Watts Bar Nuclear Plant, Unit 2  
NRC Docket No. 50-391

**Subject: WATTS BAR NUCLEAR PLANT (WBN) UNIT 2 – STAFF INFORMATION REQUESTS RESULTING FROM NRC DECEMBER 15, 2009, MEETING WITH TENNESSEE VALLEY AUTHORITY (TVA) REGARDING DIGITAL INSTRUMENTATION AND CONTROLS REVIEW AND NRC CLARIFICATIONS TO THE REQUESTS PROVIDED DURING FEBRUARY 18, 2010, TELEPHONE CONFERENCE CALL (TAC NO. ME0853)**

### **WBN Unit 2 – Staff Information Requests Resulting From NRC December 15, 2009, Meeting With TVA Regarding Digital Instrumentation And Controls Review and NRC Clarifications To The Requests Provided During February 18, 2010 Telephone Conference Call**

**Revised Markup of ICS Plan Drawing**

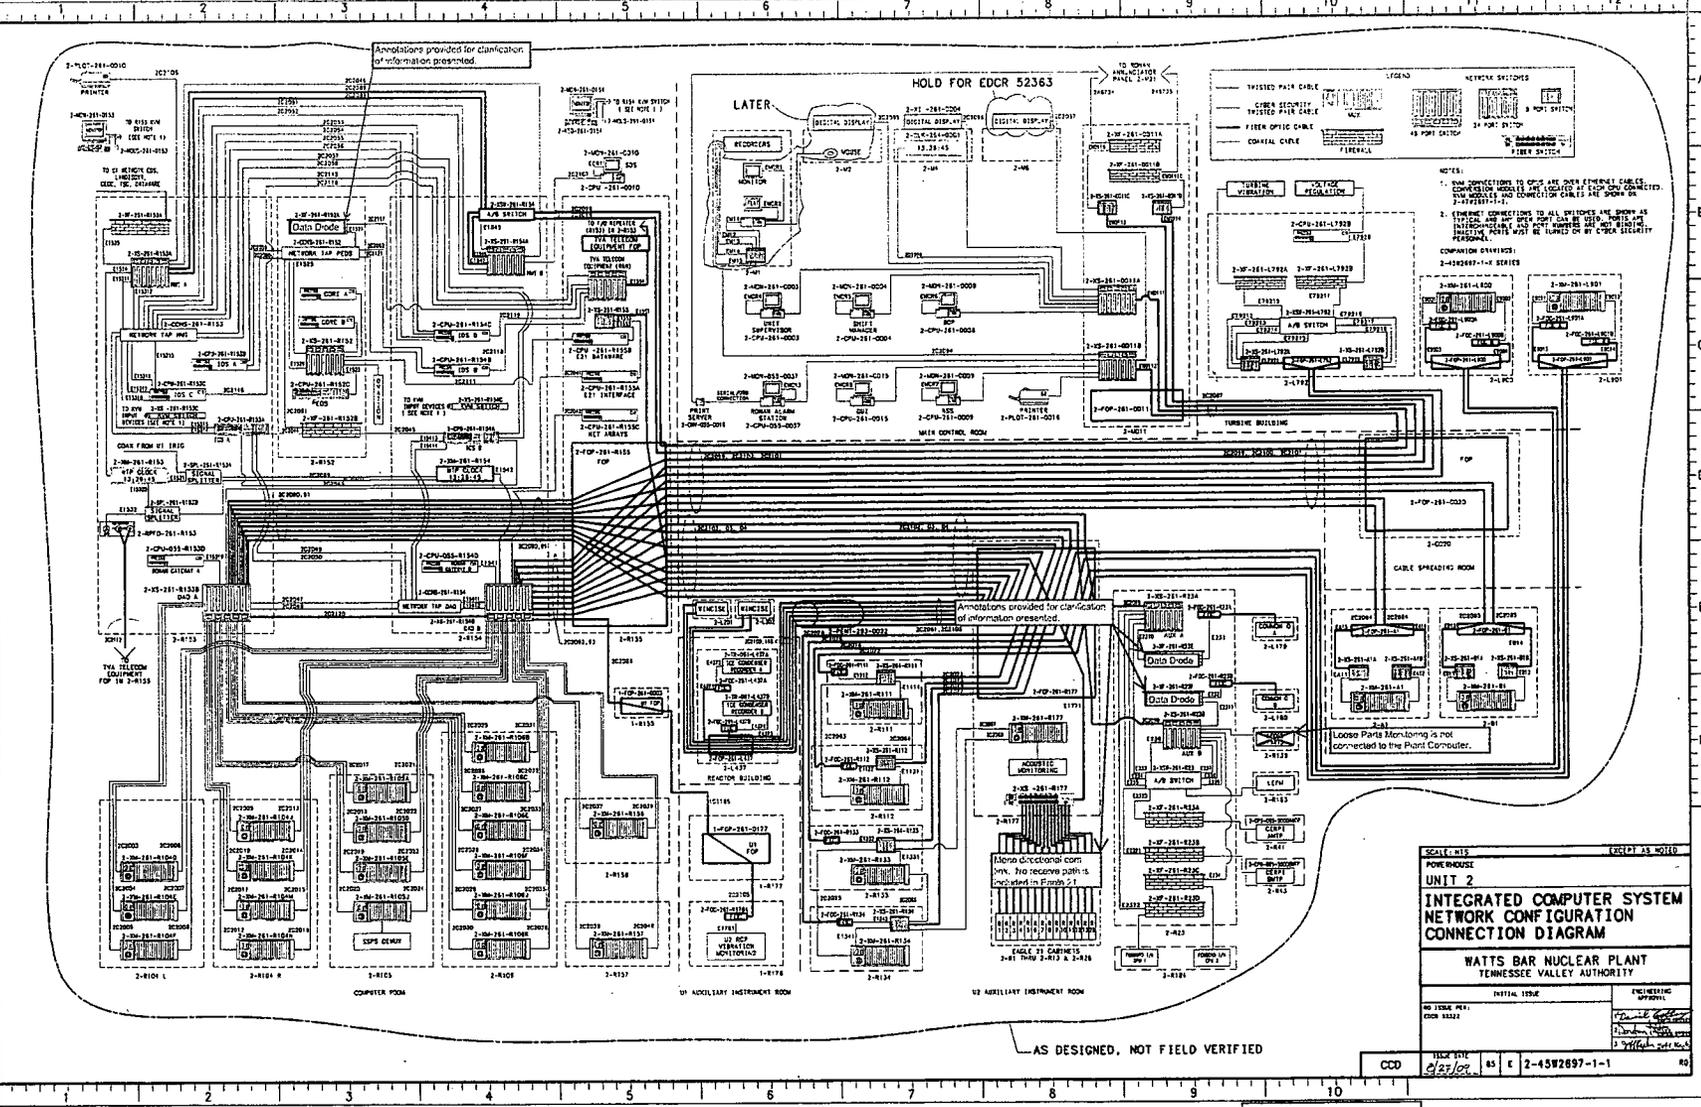
An additional change to the ICS drawing markup submitted in response to Question 14 is required. The ICS network connection to the LPMS (grid location F-9) was included during the planning stages of the WBN Unit 2 ICS project. TVA determined this connection is not required and plans to remove it at the next revision of the drawing. A revised markup of the drawing is attached (Attachment 6).
